Rapid Service Update (RSU)

Potential Sunroof Noise

PARIS & SERVICES							
REFERENCE:	TSB : 23-004-23 REV. A GROUP 23 - Body	Date:	January 31, 2023	REVISION:	23-004-23		
VEHICLES	2022 (MV) Jeep Compass This bulletin applies to vehicles built on or after **September 14, 2022 (MDH 0914XX)** and on or before October 29, 2022 (MDH 1029XX) equipped with Full Sunroof, Power Front, Fixed Rear (Sales Code			MARKET APPLICABILITY:			
AFFECTED:				□NA	□CH		
				⊠EE	□IAP		
	GWJ).	⊠SA	$\boxtimes MEA$				
CUSTOMER SYMPTOM:	Customers may comment on the following: • Audible sound coming from the rear sunroof area over rough roads.						
CAUSE:	Missing adhesive between interior roof frame panels.

This bulletin supersedes Technical Service Bulletin (TSB) 23-004-23, date of issue January 07, 2023, which should be removed from your files. All revisions are highlighted with **asterisks** and include an updated build date.

Fig. 2
Adhesive Application Location

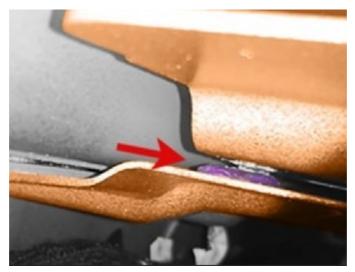
3. Seal the rear roof frame panels together (Fig. 2) . Apply a large bead of adhesive between the panels and let dry.

NOTE: Both the right and left sides of the roof panel will need to be sealed.
